**Errata to  
Fundamentals of Water System Design,  
I-P Edition (2000)**

**January 5, 2016**

Figure 8-14. Typical Performance Curve  
6 in. Suction x 8 in. Discharge x 9.5 in. Impeller.

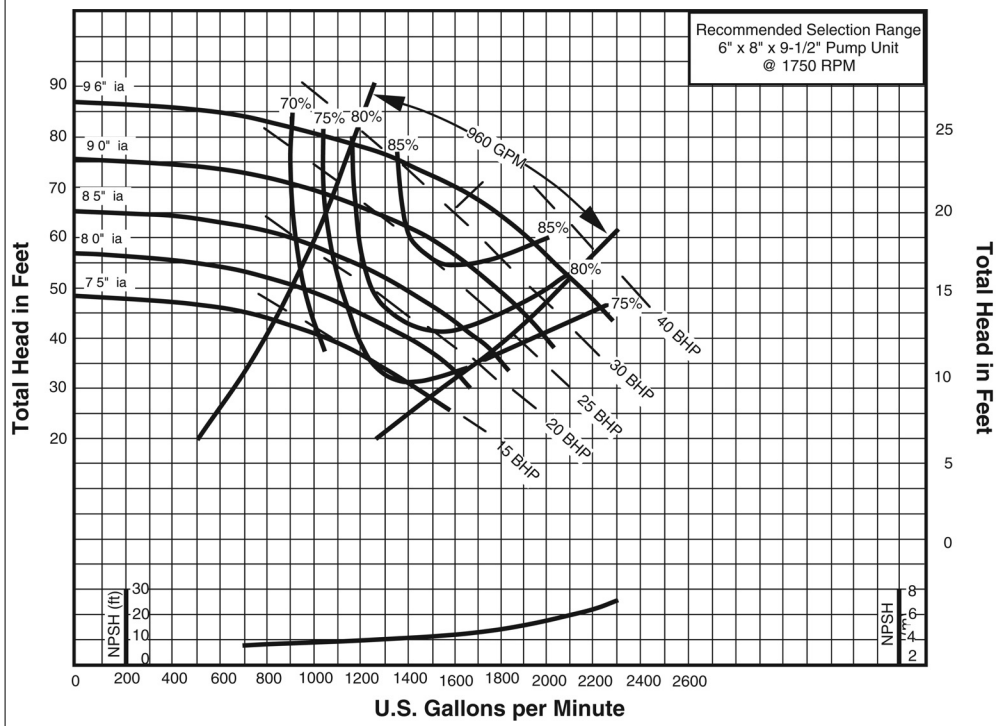
8:15

Figure 8-14

Figure 9-8. Double-Effect Direct-Fired Chiller

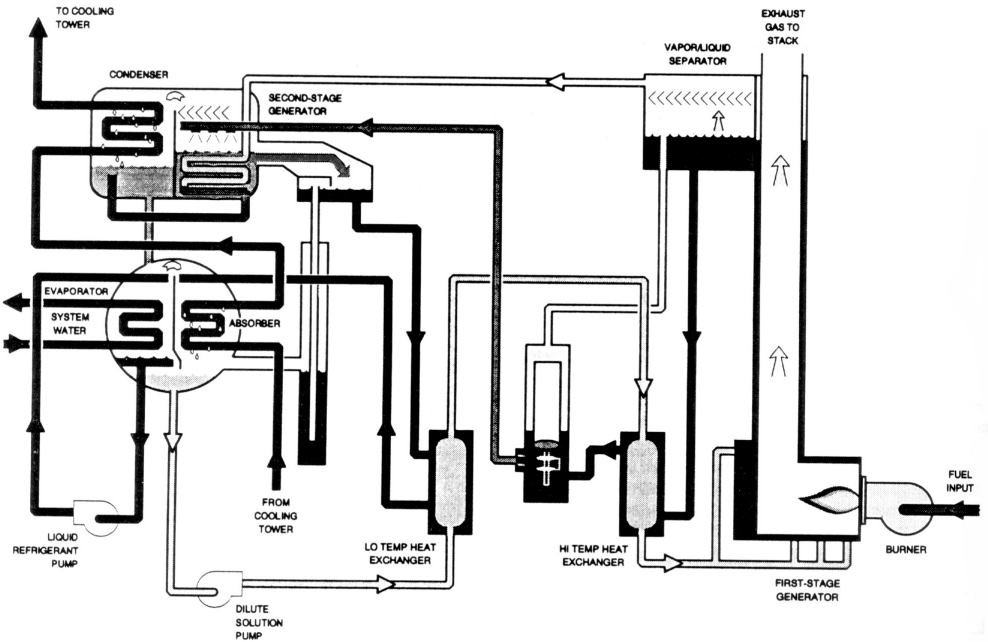
9:11

Figure 9-8

Figure 9-21. Work order module.

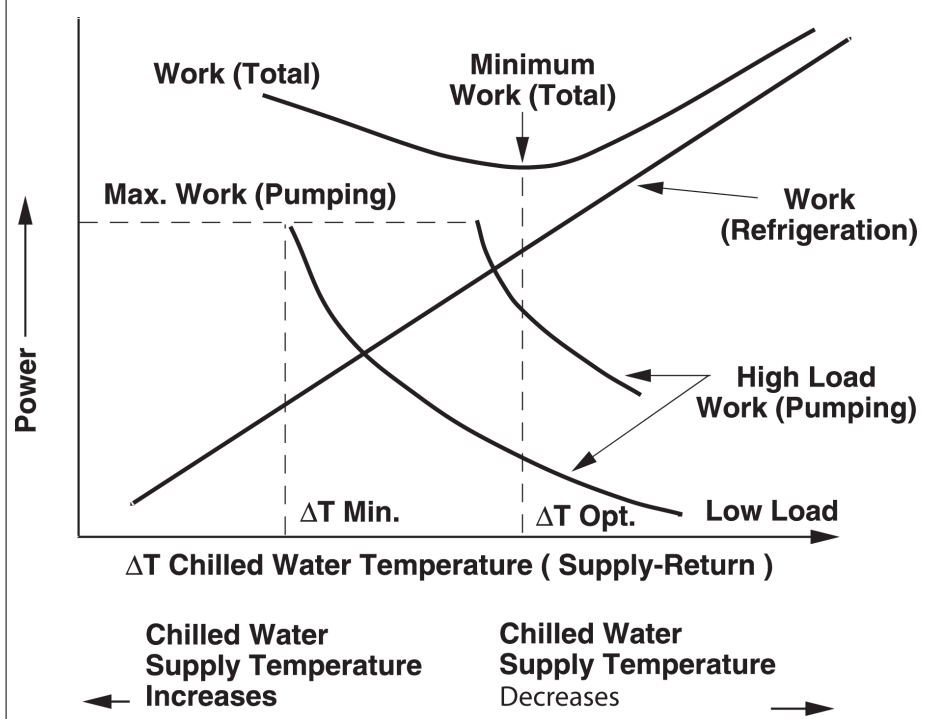
9:22

Figure 9-21
